Visual differences of the tensioning pulley 531 0628 30

LuK AS Part No.: 531 0628 30

OE-No.: 03G 109 243

Issued 11.2007
INA 0012

Fig. 2: 531 0628 30 (new version)

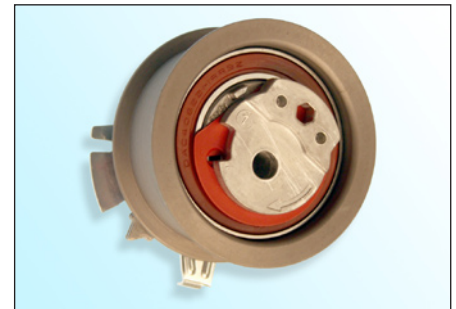
- Cam made from sinter metal
- Surface coat E-Coat (black)
- black bearing seal

- Cam made from cast aluminium
- Surface coat Zinc phosphorous (light brown)
- brown or black bearing seal

As part of the ongoing development of our products, the tensioning pulley **531 0628 30** has been modified.

The „old version“ of the tensioning pulley is **not** made completely redundant and can still be used and assembled in accordance with the instructions provided by the manufacturer!

When assembling the „new version“, ensure that the surface coat of the tensioning pulley is **not** damaged!
